Job: 1606-037
Wildcat Const-Pump Station
Sewage Treatment Plt 2
2305 E 57th Street S.
Wichita, KS 67213

Submittal Title: Switchgear & VFD's

Switchgear & VFDs – Spec Section 26-000 – Submittal No. 1 Review Notes – Supplier Responses

ENCLOSURE OUTLINE & GENERAL ARRANGEMENT

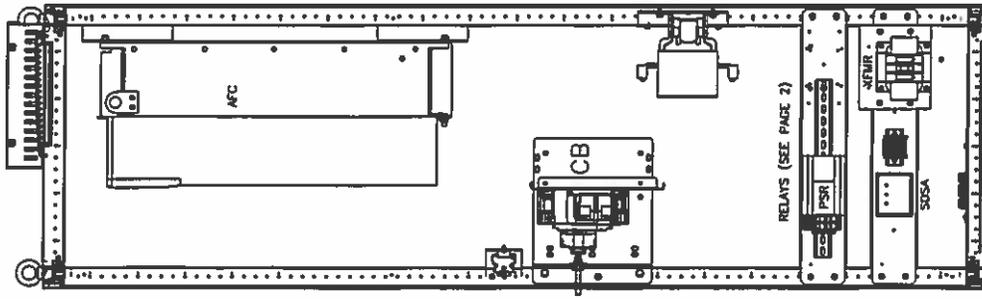
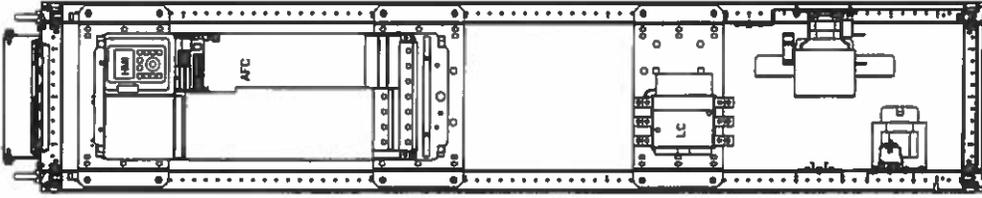
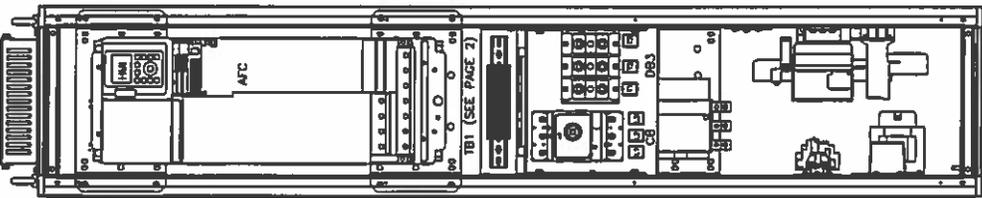
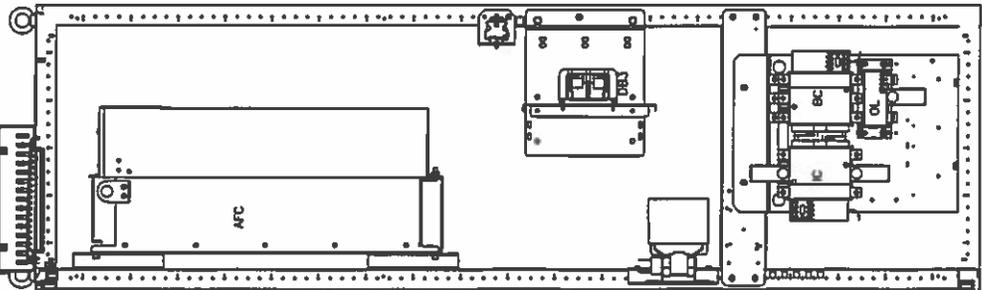
8.1.1 Verified the drive system is rated for 40 deg C continuous duty. The VFD is rated for 145 amps output current, but the drive system and bypass is rated for 124 amps at 480 volts.

8.5 The drive includes a Category C3 EMC Filter and RFI shielding to meet IEC 1000: (Electromagnetic Compatibility) and IEC 801-2,-3,-4,-5: (Immunity Tests) standards.

8.6.3 Fast acting fuses are exclusive to the VFD and the bypass circuit is protected by the circuit breaker disconnect. Additionally, an input contactor to the VFD is provided to provide isolation for service during bypass operation.

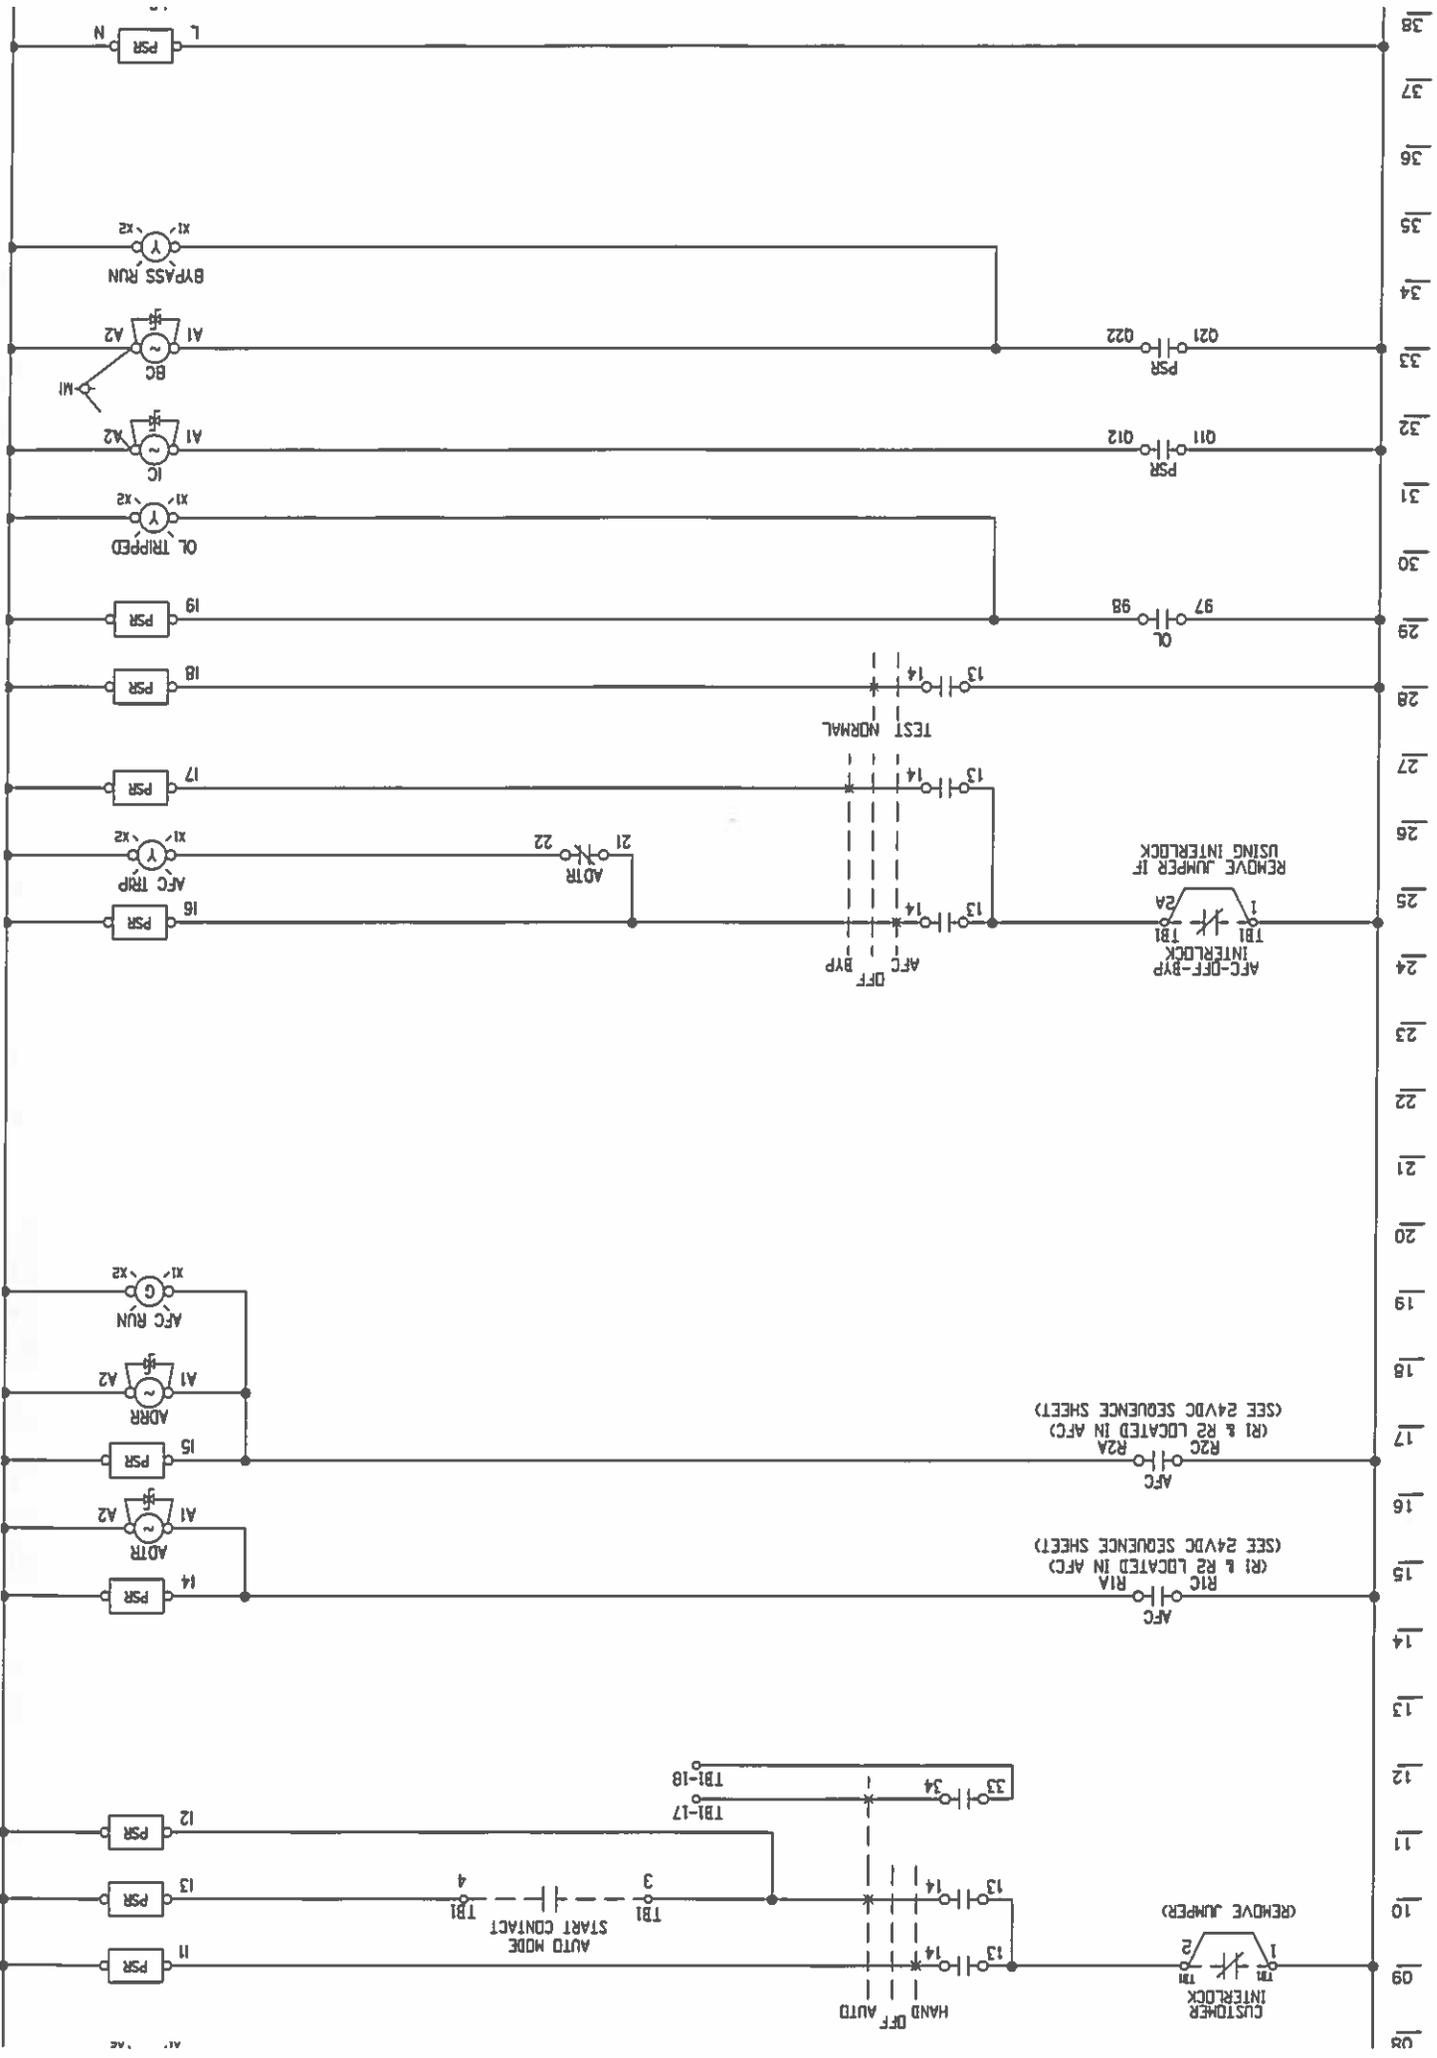
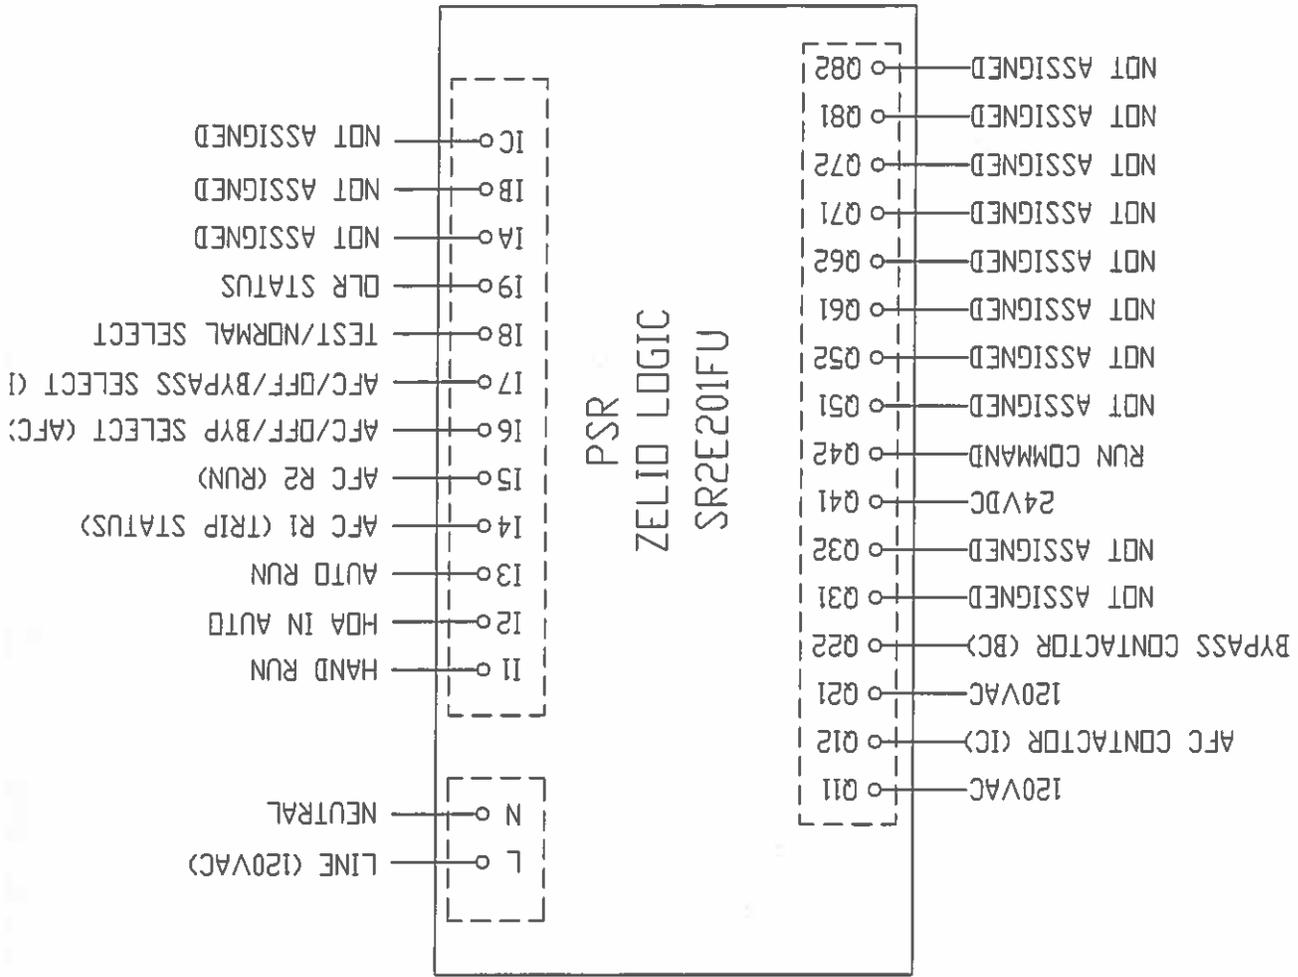
8.3.4 Three Form C Relays will be wired to the VFD extended relay module, and customer wiring for the Form C contacts will be supplied on the field wiring terminal block.

8.4.1 Verified with Ed McGrath of R E Pedrotti that all interface with the control system will be via hard wiring. Field wiring terminals will be provided for the following signal requirements: an analog input for speed reference, an analog output for speed feedback, three discrete relay outputs for Run / Fail / Auto indication, and one discrete input for the auto start command. An RS485 port is available with Modbus and CAN open comms. Additionally, an Ethernet port is available for communications. Optional networks available are Profibus and DevuceNet.

8.6.6 Additional relays to those found on the drawings or the bill of materials can be provided. In addition to function, please provide the device (ie, VFD, bypass contactor interlock, control power, selector switch) that is expected to provide the function . A wiring diagram or notes added to the drawings in addition to the description is desirable.

8.6.11 Manual or automatic bypass functionality can be provided. **Automatic bypass is not recommended by the drive manufacturer**, because a motor fault that would trip the drive and initiate a transfer to bypass could cause further system damage.

8.6.12 An adjustable current sensor will be provided to detect loss of load when in Bypass mode.
